01 Floor plans

Level 10 Floor Plan

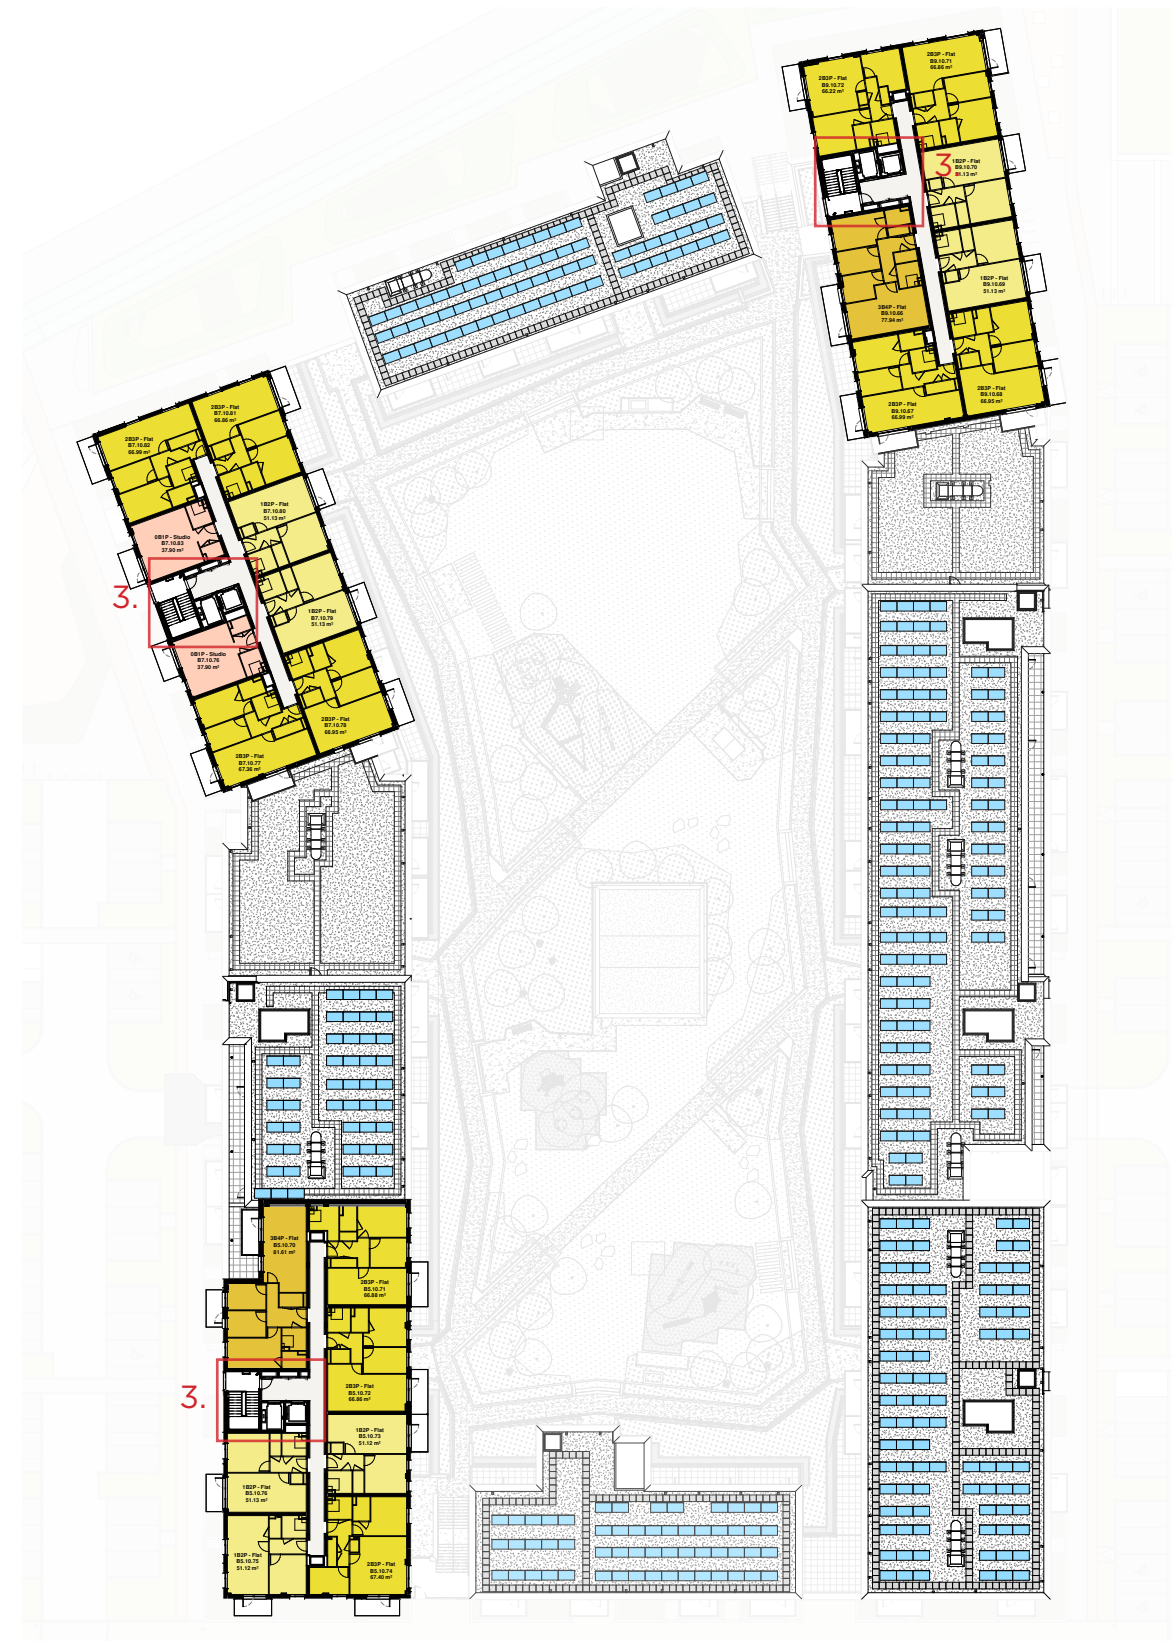
1. Omission of podium entrance canopies; security risk to adjacent apartments at first floor.
2. Addition of plant housing for car park smoke extract fans as per developed fire strategy
3. Updated core layout as per developed fire strategy; evacuation lifts added to Blocks 4 and 8
4. Reconfiguration of apartment layout. Overall mix remains as consented.

Roof Level Plan

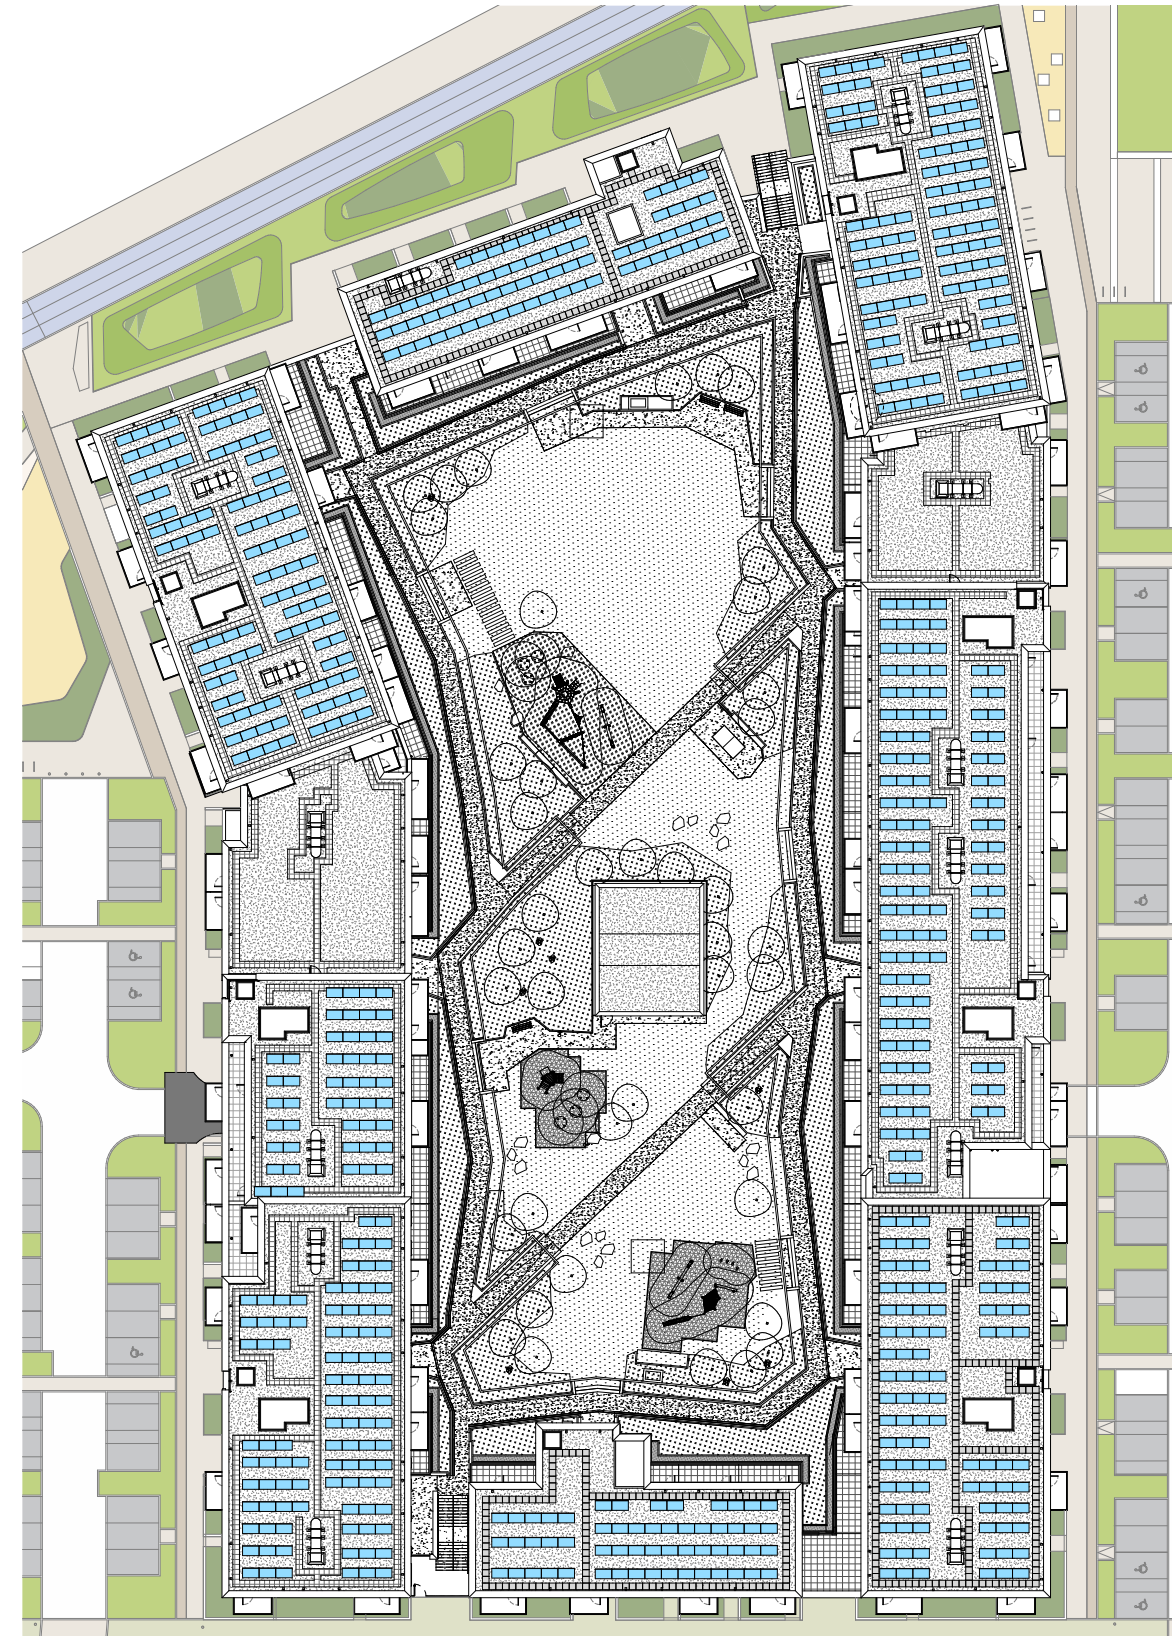
1. Omission of podium entrance canopies; security risk to adjacent apartments at first floor.
2. Addition of plant housing for car park smoke extract fans as per developed fire strategy
3. Updated core layout as per developed fire strategy; evacuation lifts added to Blocks 4 and 8
4. Reconfiguration of apartment layout. Overall mix remains as consented.
